AERONAUTICAL CHARTING FORUM
Instrument Procedures Group
October 29, 2013

FAA Control # 13-02-314

Subject: Bank Angle Requirements on Instrument Approach Procedures

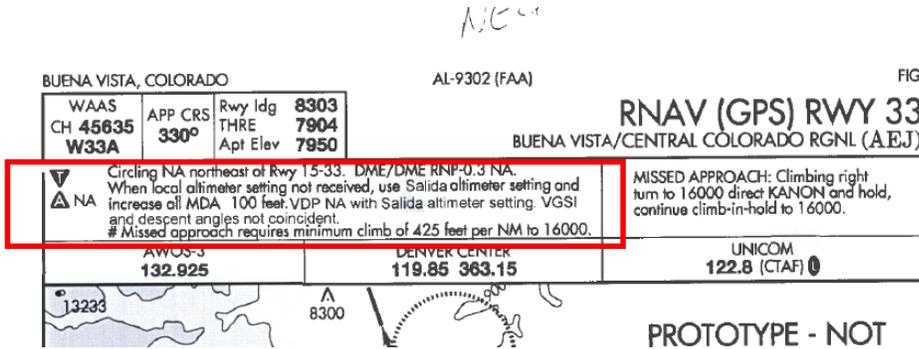
NBAA provides the following example of a procedure recently posted to FAA's Coordination web site for Buena Vista, CO (AEJ) as an example of an approach that uses both a higher-than-standard climb gradient and a greater-than-18 degree bank angle requirement in the missed approach:

Unfortunately, the IAP does not inform the pilot that the missed approach segment was assessed using a 25 degree bank angle. This information is only available in the 8260 Form Package – Part C Remarks:

Steeper bank angles are normally not a concern when used with a standard climb gradient in the missed approach segment. However, on missed approaches using a higher-than-standard missed approach climb gradient, especially when it extends to a substantial height of airport elevation (e.g., Buena Vista, CO - 425'/NM to 16,000 ft.), pilots must consider the climb performance loss resulting from the steeper bank angle when evaluating their aircraft's capability to achieve the required climb gradient. For many turbine aircraft, the minimum maneuvering speed for configuration limits the bank angle to 15 degrees. The pilot must be aware of this information when selecting the appropriate missed approach climb configuration and minimum climb-out speed, both of which will greatly influence the all-engines-operating climb performance of the aircraft.

Recommendations: NBAA recommends that FAA amend Order 8260.19E adding a requirement to publish in the instrument approach procedure briefing strip the required bank angle used in the missed approach segment procedure when the value exceeds the recommended 18 degrees in FAO 8260.58, Volume 6, paragraph 1.2.1.

NBAA further recommends that the FAA Aeronautical Information Manual furnish guidance stating that the missed approach procedures may require bank angles up to 25 degrees in combination with higher than standard climb gradients. It should also include an advisory that pilots must evaluate the combination of bank angle, minimum maneuvering speed, and known aircraft performance in deciding whether to use the line-of-minima associated with the higher than standard climb gradient.
